## VERIFICATION OF INTERIM REDD+ PERFORMANCE INDICATORS UNDER THE GUYANA-NORWAY REDD+ PARTNERSHIP

Monitoring Period:  
1 October 2010 to 31 December 2011 – Year 2

REPORT No. 2012-1402

Figure: Relation between timber extraction rate and percent change in above and below ground biomass. The GFC Code of Practice extraction rates are less than 20 m3/ha.

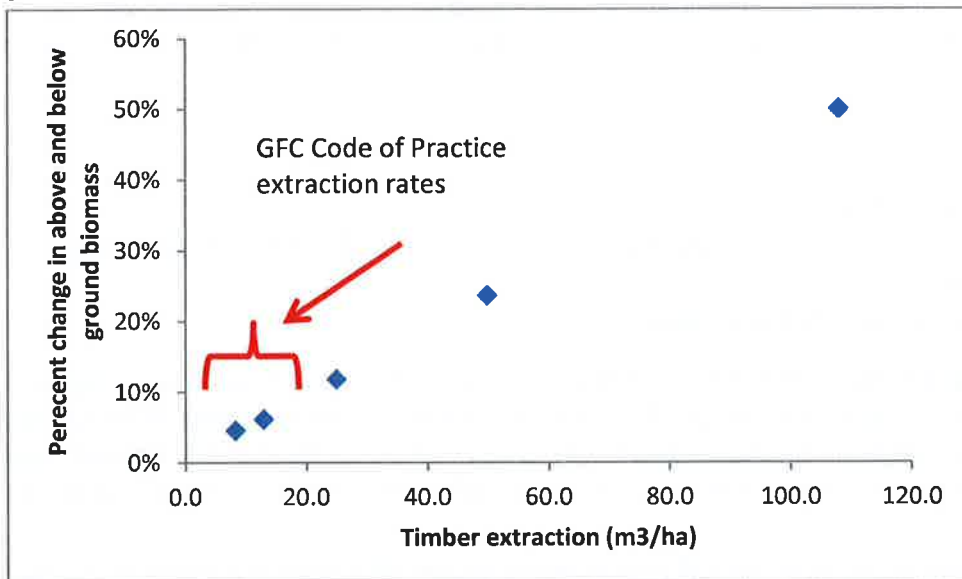
*While the method should give a good estimation of degradation where clear breaches in the canopy can be observed from RapidEye imagery, we are concerned that significant biomass loss can take place without there being an observable breach in canopy. Supplementing information on how this is treated should be added.*

*We then estimated the reduction in biomass for extraction rates higher than the code of practice levels and also estimated how much timber would need to be extracted to reduce the biomass of the forests by 50%. The results are given in the following table and figure.*

**DNV:** The verification team assessed the comment and the response as well as the modification in the Section 6.3 p.60 of the report to be satisfactory. During the audit the audit team examined in detail the process of damage assessment and the associated modelling and found that the process applied provided detailed information about the expected damage impact following logging activities that could not necessarily be observed through the RapidoEye images.
